environmental statement

related to construction of
**SHEARON HARRIS
NUCLEAR POWER PLANT
UNITS 1, 2, 3, and 4**

DOCKET NOS. 50-400, 50-401, 50-402, & 50-403

May 1973

FIGURE 2.2 STREAMS AND RIVERS IN THE VICINITY OF THE PROPOSED SHEARON HARRIS PLANT

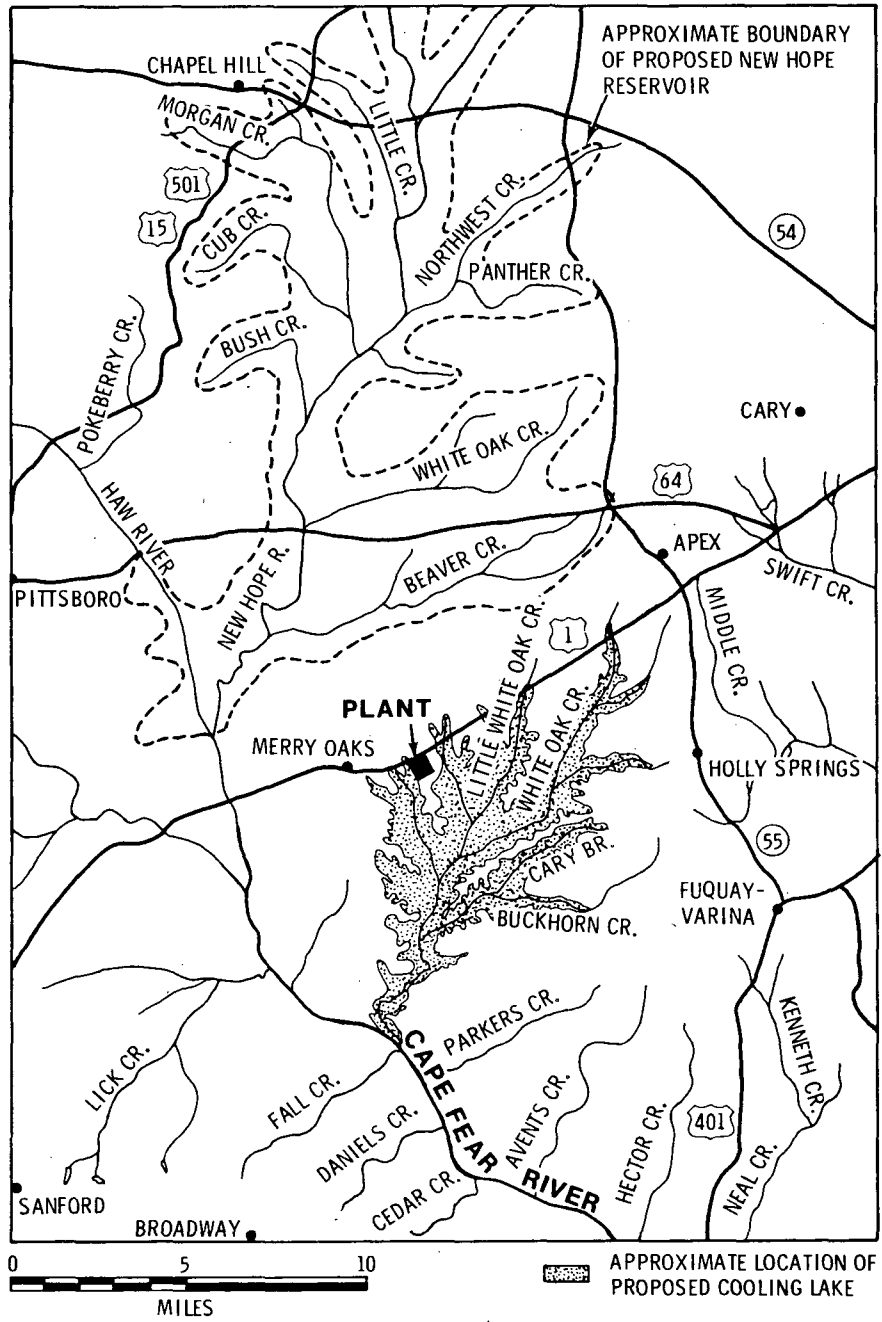
Comment: Figure 2.2 should show the New Hope Lake project.

FIGURE 1
AEC MODEL

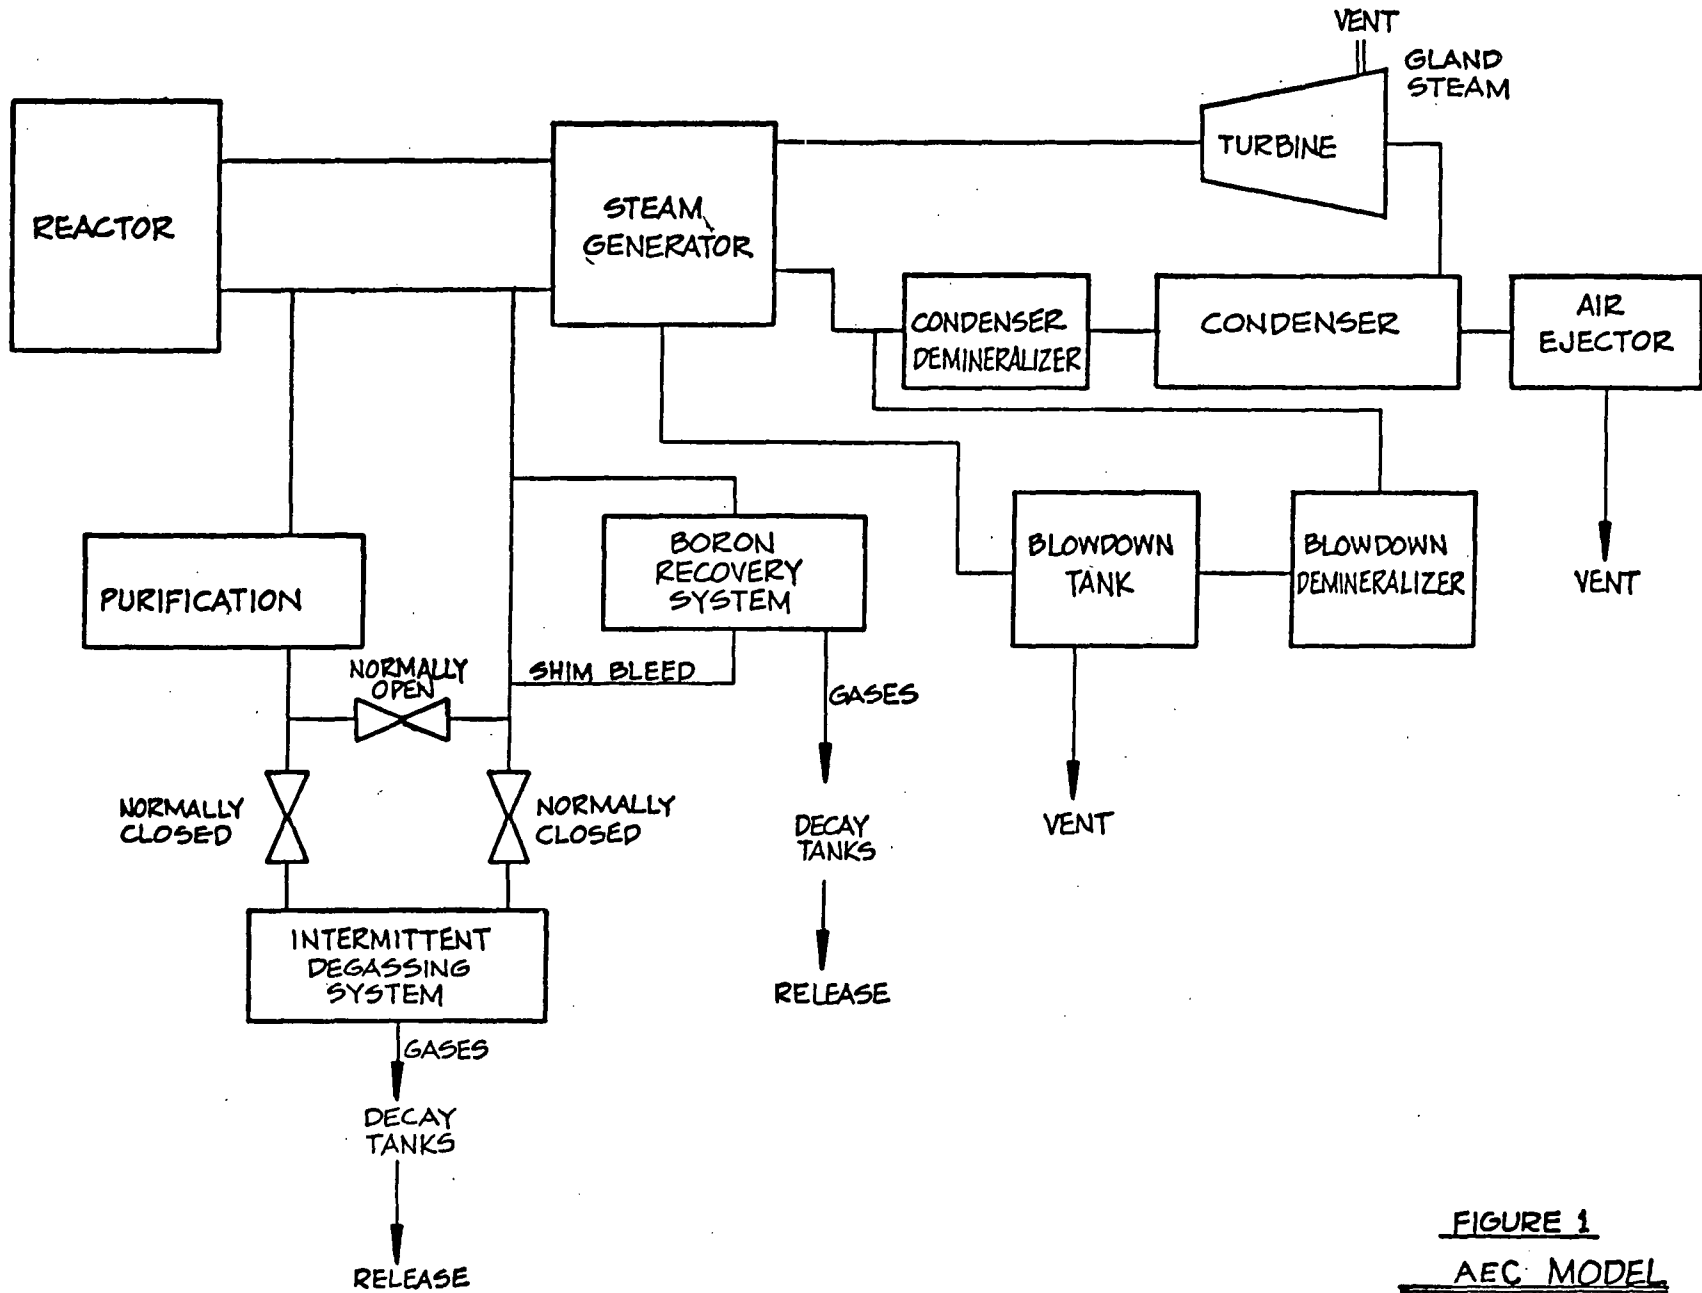
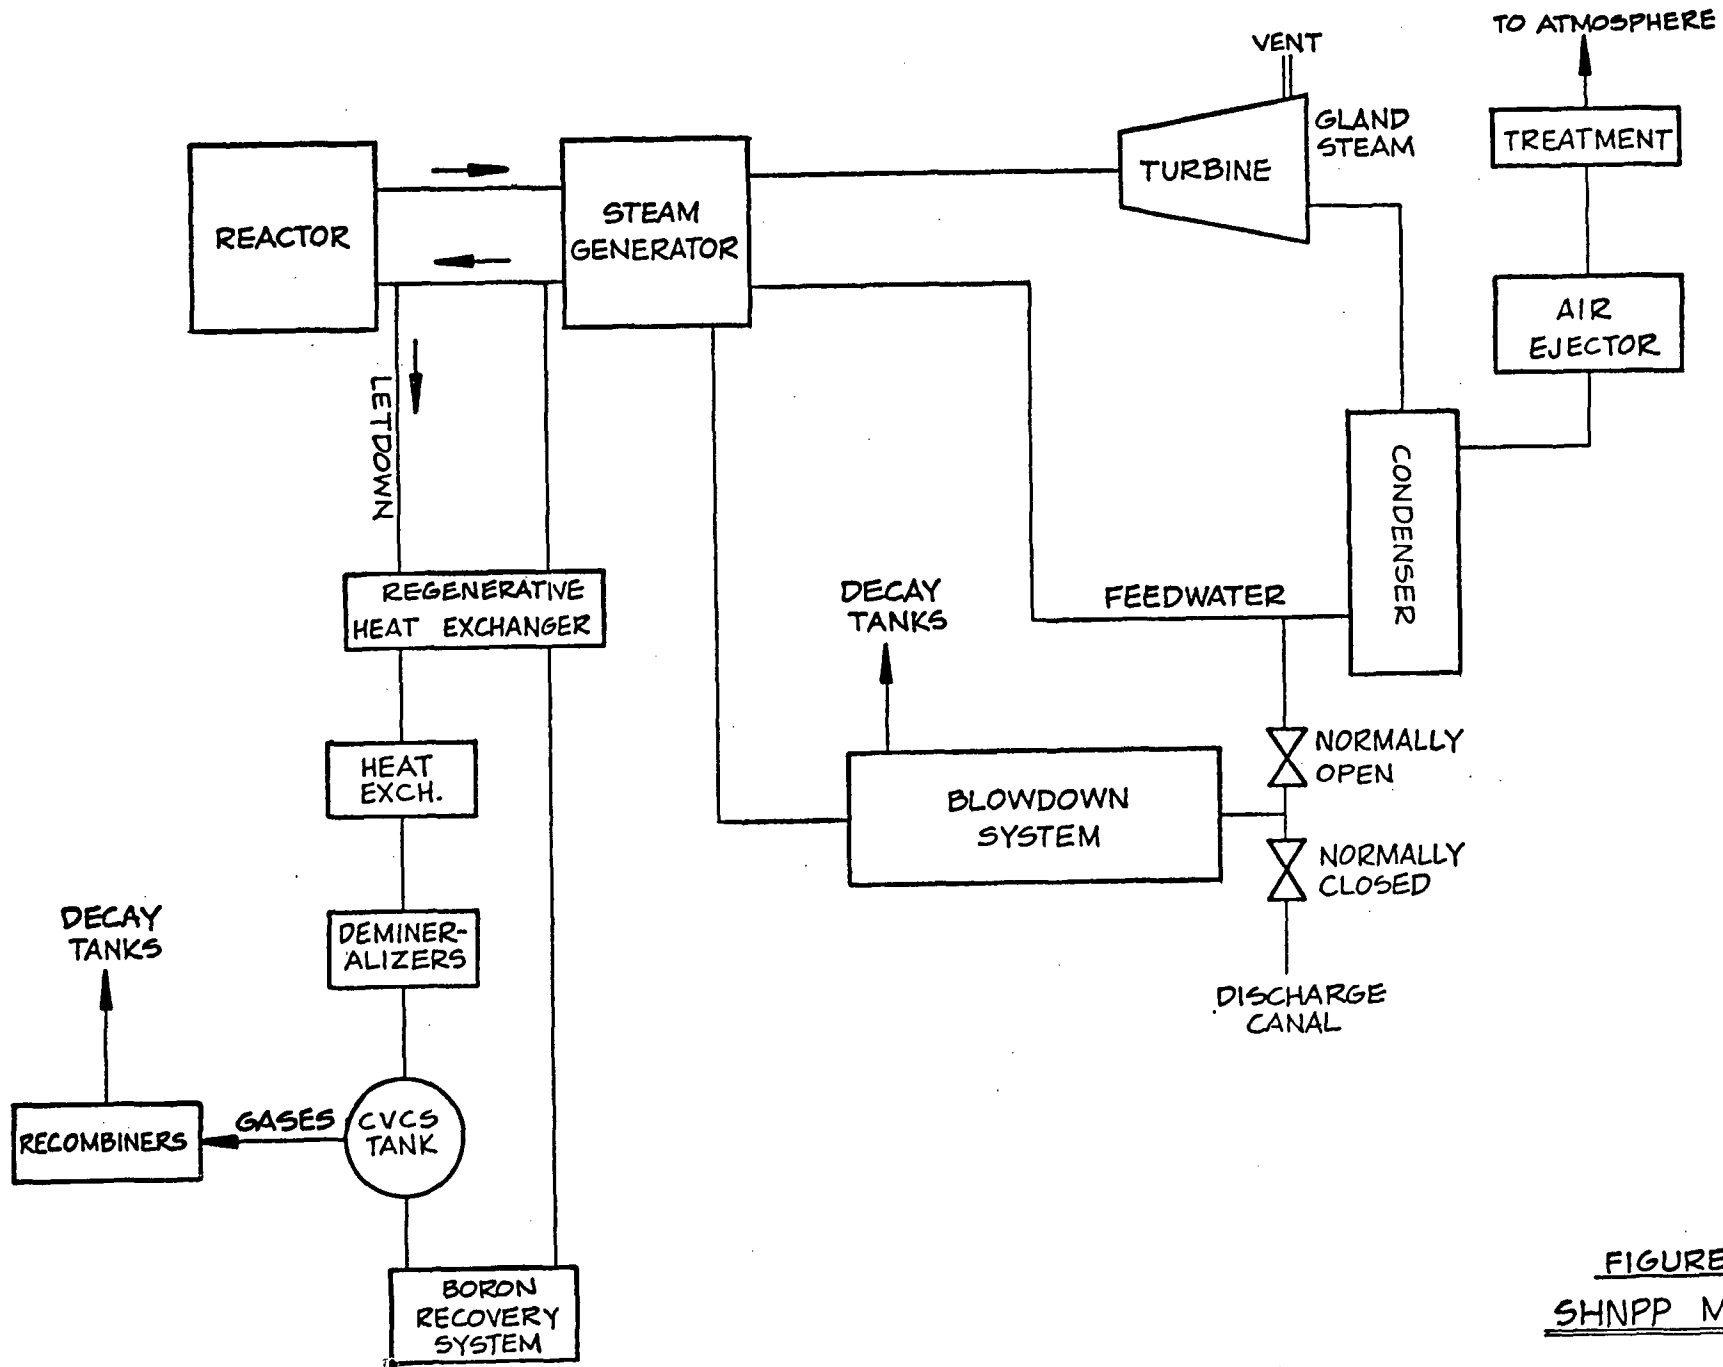
The liquid radioactive waste system will consist of the process equipment and instrumentation necessary to collect, process, monitor, store, and recycle and/or dispose of processed radioactive liquid waste. The liquid waste treatment system is divided into three main parts: the boron recycle system which includes a boron thermal regeneration system for turbine load-follow operation; Waste Channel A which will collect all aerated wastes from leak and drains; and Waste Channel B which contains and treats non-reactor grade water. These subsystems are shown in Figure 3.5 of the Draft Environmental Statement. Our review of this schematic reveals the following oversights: (1) recycle line from the waste evaporator condensate tank to the condensate demineralizer and filter in Waste Channel A and (2) blowdown tank (1/unit) should be a steam generator blowdown system with a liquid decontamination factor of 3,000 (minimum) at design activity levels (no atmospheric flash tank).
